DEPARTMENT OF ENVIRONMENTAL QUALITY
AIR QUALITY DIVISION
ACTIVITY REPORT: Self Initiated Inspection

| FACILITY: HURON CASTING INC. & BLUE DIAMOND STEEL CASTING | | SRN / ID: B7013 |
| SUBJECT: Unannounced Inspection | | |

Image 1(-) : Ducts above No-Bake Furnace

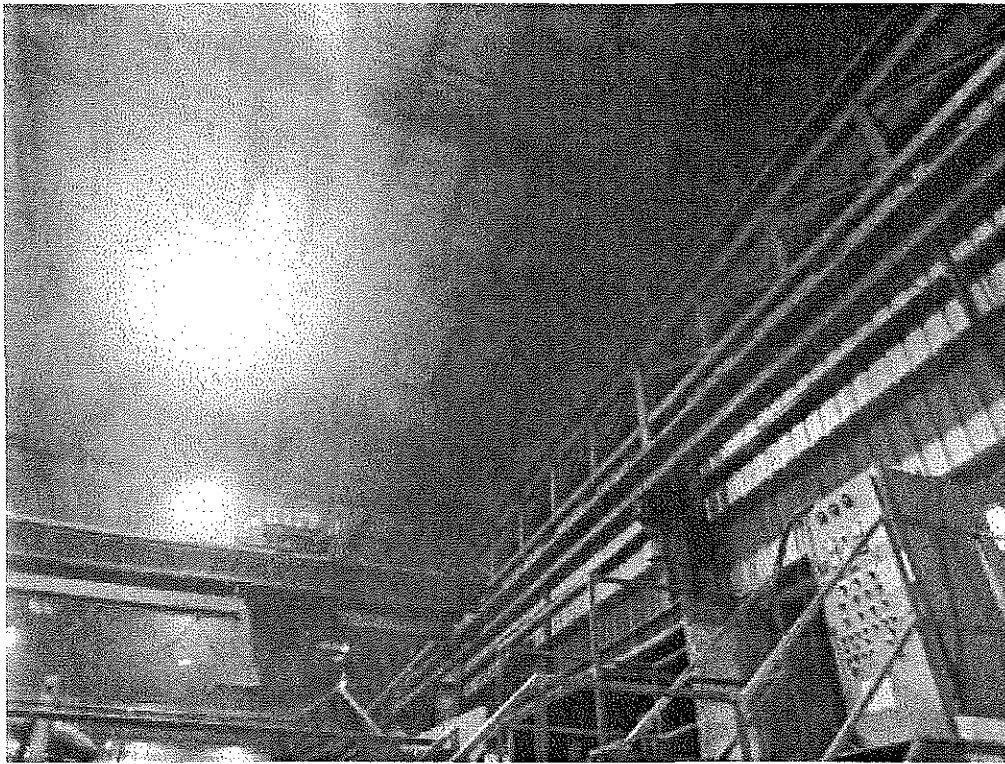
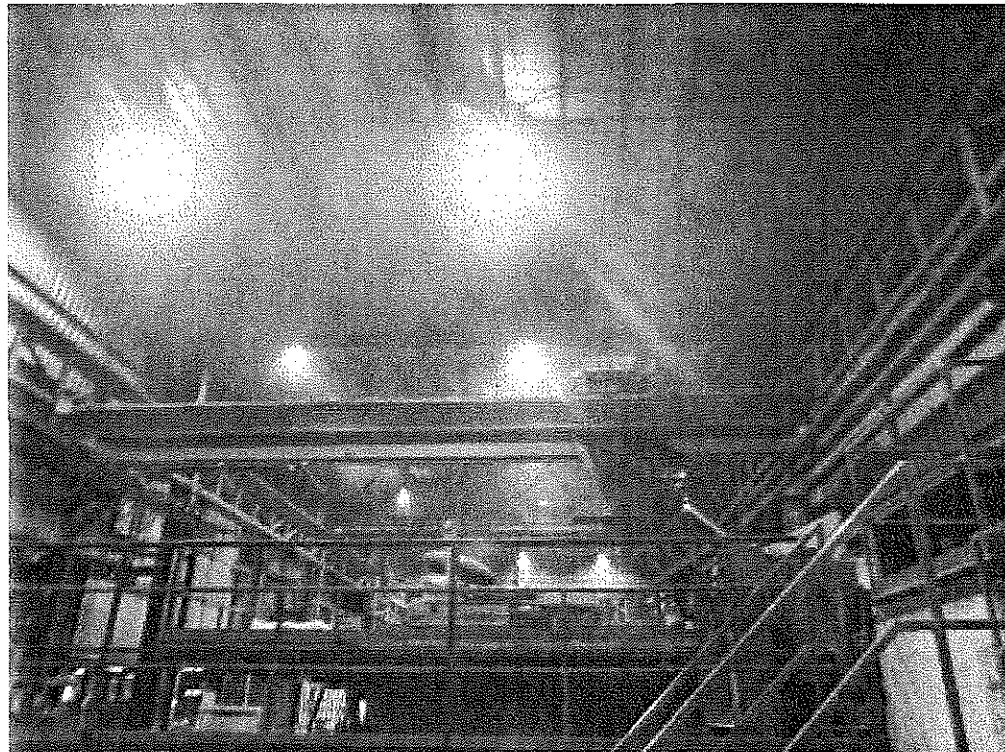
As observed during the inspection, capture consists of three flared horizontal ducts that are located approximately 10 feet behind and 40 feet above the furnaces. Based upon this set-up, one could only expect minimal capture efficiency, which is what was observed and documented during Subpart ZZZZZ compliance testing. It does not appear that the capture system meets acceptable engineering standards as required by 63.10895.

(Images 1 & 2, photos show ducts near the roof)

Status: Non-compliant

Image 3(-) : Electric Arc Ladle Furnace

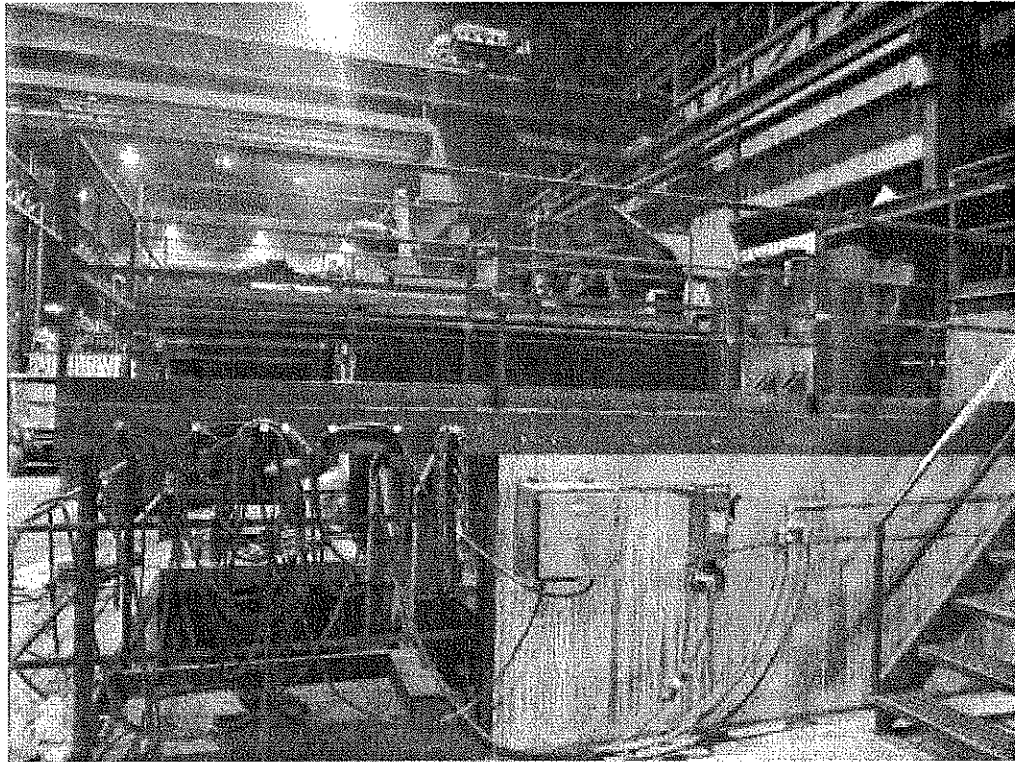
(Image 3 – Electric Arc Ladle Furnace, Images 4 & 5 – Vacuum Degassing Unit)

During the inspection staff inquired about the permitting status of the electric arc ladle furnace and vacuum degassing unit that the facility was in the process of installing. The facility stated that the processes were being installed as exempt from the requirements to obtain a permit to install. Upon request the facility provided a written PTI exemption justification. In summary, the facility stated that the vacuum ladle degassing unit is exempt from requiring a permit to install pursuant to R336.1285 subpart (c)(iii). The facility further stated that the degassing unit is not an emission unit, and the dust generated appears to be minimal. In regards to the electric arc ladle furnace, the facility stated that it is a replacement for the 8-ton induction furnace that was not installed. The facility further stated that the ladle furnace is a warmer, and process materials are shielded by slag and argon. The facility expected emissions to be significantly below permitted levels and offered to conduct emissions testing.

In regards to the electric arc ladle furnace, Rule 201 does not allow for the replacing an 8-ton induction furnace with an electric arc ladle furnace for which the emissions are unknown at this time.

The installation of a vacuum degassing unit and electric arc ladle furnace prior to obtaining a permit to install is a violation of Rule 201.

Image 4(-) : Degassing Unit

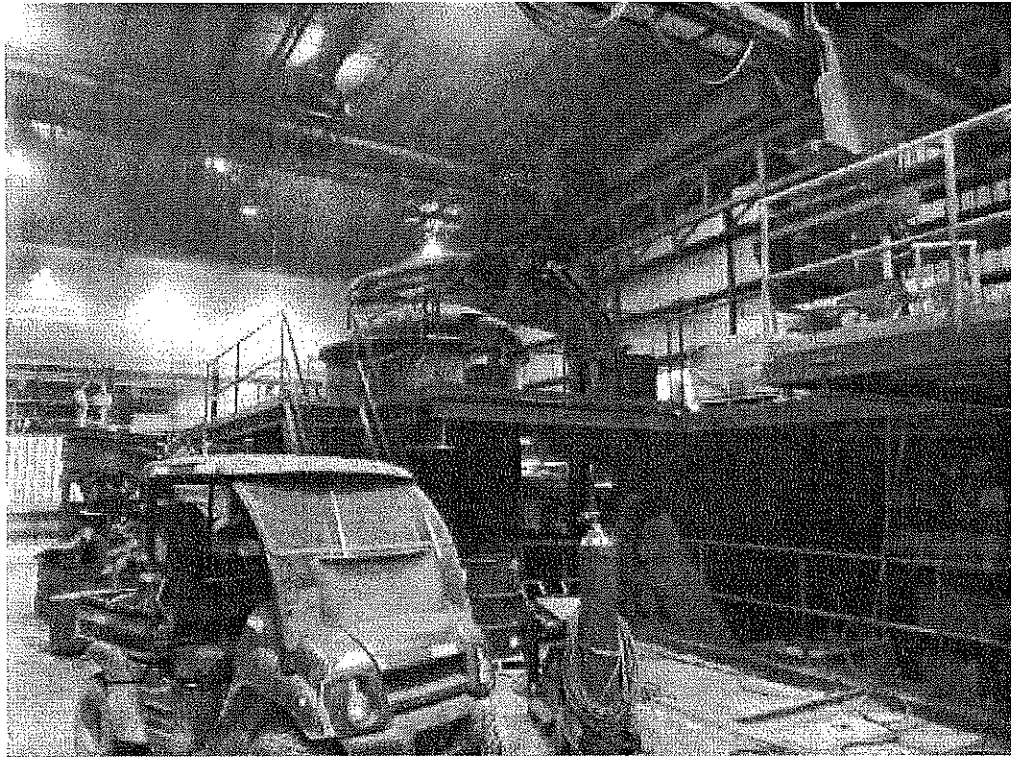
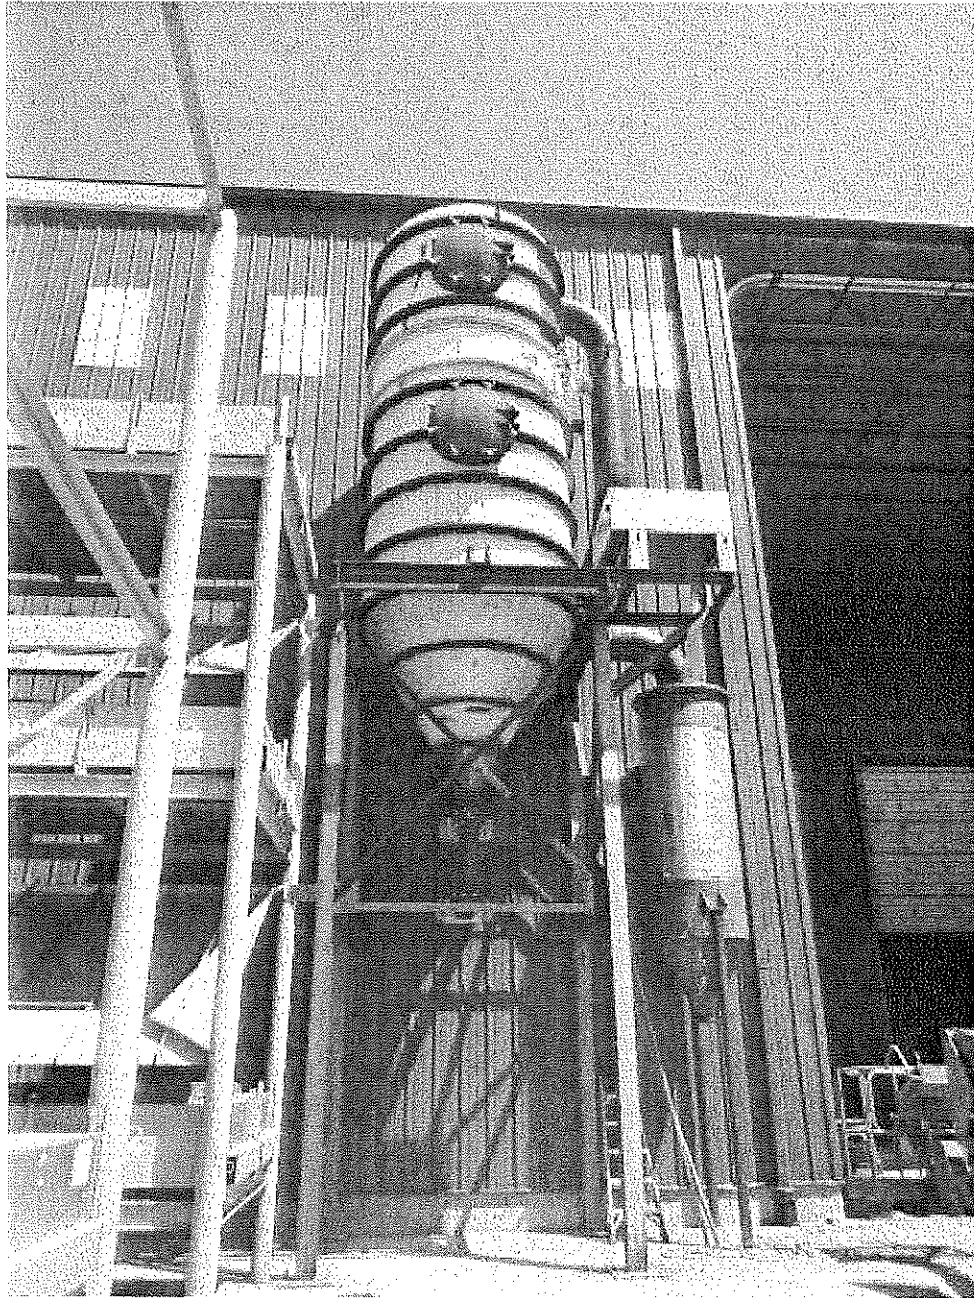
Sufficient emission data has not been provided to determine if installation of the vacuum ladle degassing unit will result in emissions that do not exceed the levels described in and allowed by the permit to install.
